SUBMISSION TO M5 EIS

Paul Waddington
50 Lyne Street Alexandria

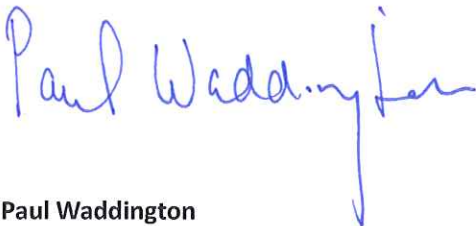
Finally, I strongly object to the quality of the EIS. There is too little information on the traffic volumes that will occur in Alexandria, and there is also conflicting information on possible mitigation strategies. Although the diagrams in the EIS show right-hand turn lanes in all four directions at the Sydney Park Road/Euston Road intersection, the text of "New M5 EIS Vol 2B App G Traffic and Transport" instead indicates that there will be a "banned right turn from Mitchell Road into Sydney Park Road [because of] the banned right turn southbound at the Sydney Park Road / Euston Road intersection". The text also indicates that there will be a "north-bound lane [which] will go as far as Maddox Street, where it becomes a new left-hand turn lane", but the diagrams do not show this. Not having clarity on which of these two scenarios is planned makes informed consultation impossible. If these right-hand turns into Sydney Park Road are not permitted, there will be enormous volumes of traffic on local roads as drivers try to rat run

which as a cyclist gives me considerable cause for concern. Likewise, the extra left-hand turn lane, if it is actually planned, seems destined to drive traffic onto local roads.
